Design Advisory Board

Tuesday, October 8, 2024, 3:00 PM

To: The Design Advisory Board
From: Mary O'Neil, AICP, Principal Planner
RE: ZP-24-421
Location: 176 South Winooski Avenue
Date: October 8, 2024

To: Design Advisory Board
From: Garret King
Re: 89 North Prospect Street
Date: October 8, 2024

1 GAS METER OPTIONS - SITE PLAN
Scale: 3/32" = 1'-0"

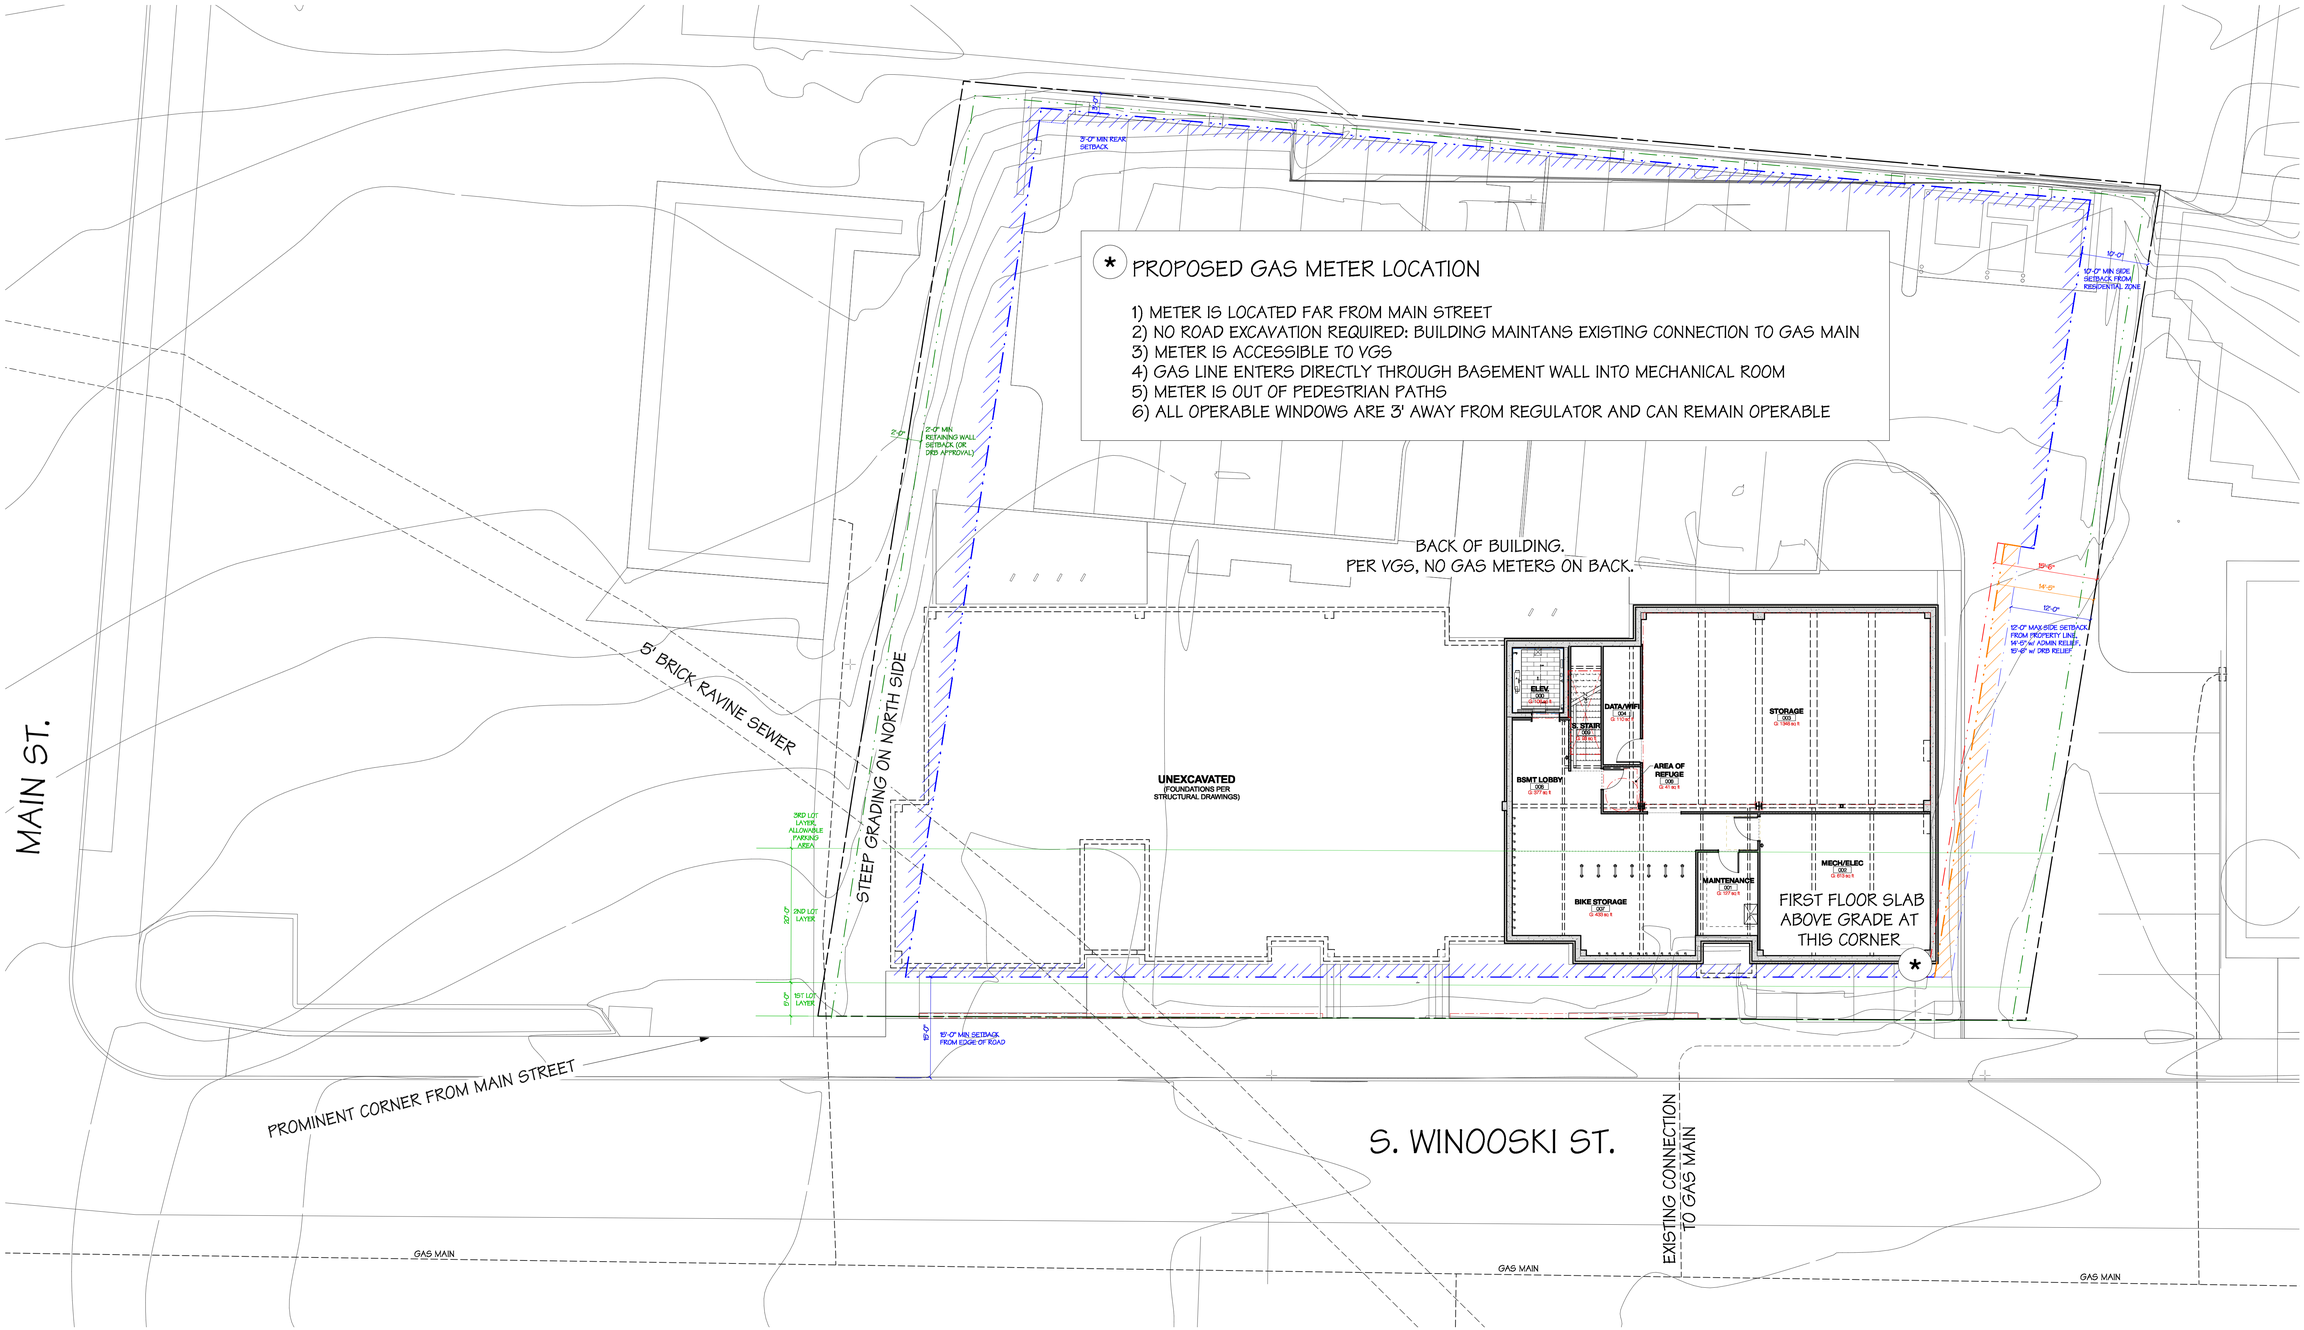
Recommendation: Denial of request for Alternative Compliance consideration for proposed utility meters on the façade of 176 South Winooski Avenue. No unique site and/or building circumstances have been articulated by the applicant requiring deviation from this prescribed standard.

The proposed location of the gas meters are at the base of an entrance ramp to the building, and immediate to the public sidewalk. Even if screening was proposed, meters can only be considered on *secondary* elevations. The location is contrary to the Urban Design Standards (14.4.13) and the intent of the Form Code to organize new development into pedestrian friendly, carefully designed downtown development that promotes interest, vibrancy, comfort and safety.
Adverse finding.

The applicant has defined no unique site and/or Building circumstances that warrant consideration of Alternative Compliance. **Adverse finding.**

Other than the applicant's desire to locate the meter on the front of the building, there is no demonstrated examination of how relocation of the meter is necessary. Without understanding the need, no analysis can be made of the degree of necessity and consideration of alternative locations. **Adverse finding.**

The project, as originally approved in March 2023 was compliant with the standards of the Form Code. The installation of a utility meter on the primary elevation of the building is not consistent with the intent of the Form District, or the intent and purpose of the section where relief is sought. **Adverse finding.**

Installation of meters on the façade will not yield a result equal to or better than strict compliance with the standards. **Adverse finding.**

North side of roof

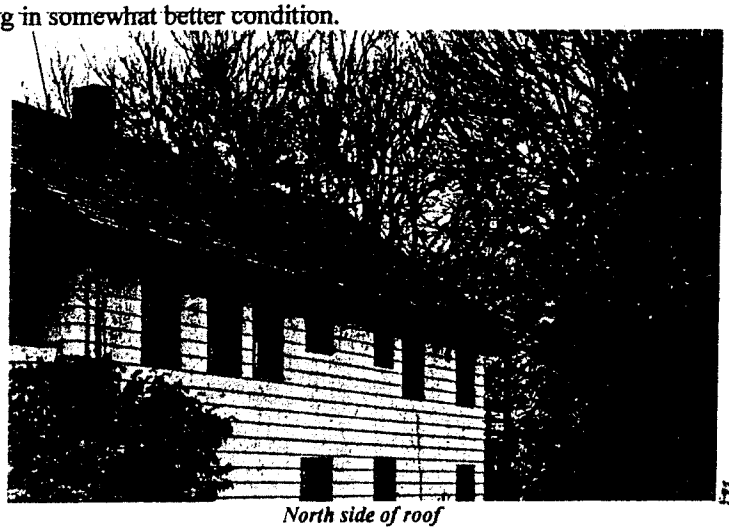
The slate on the roof at 11 Hayward St. is sized 16" long by 12" wide. The slate appears to be installed with a 2" headlap. The area of the slated area is approximately 7 Sq. (700 sq. ft.) per side, or a total of 14 Sq.

As noted above, the north side of the roof appears to be in somewhat better condition that the south side. It is possible to replace the two sides of the roof separately. For example the south side could be replaced next year and the north side left to be replaced one or two years down the road.

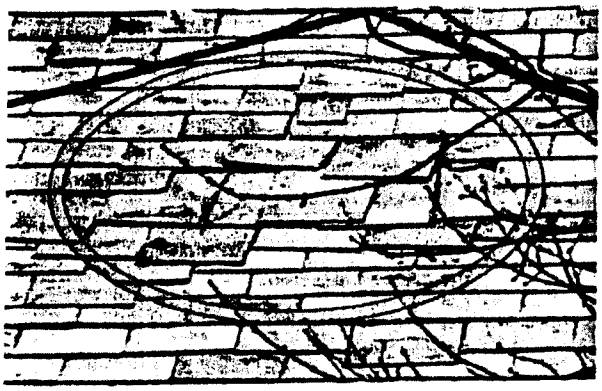
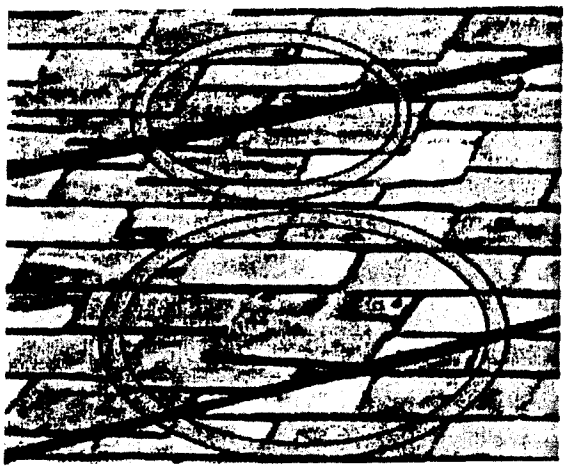
Areas of specific concern are highlighted in the photograph above, and details of selected areas are shown enlarged in the selections below.

All photographs above show an advanced condition of deterioration in both the condition of the slate, and the integrity of the roof in general.

Replacement of this roof is the only viable option in my opinion. There are several options available for the replacement. The only option I am in a position to speak to, is the replacement of the existing roof with a new slate roof. The best option for slate is a Vermont slate in either "Sea Green" or a Semi-weathering Gray-green. These slate fade over time to shades of brown, tan, and buff.
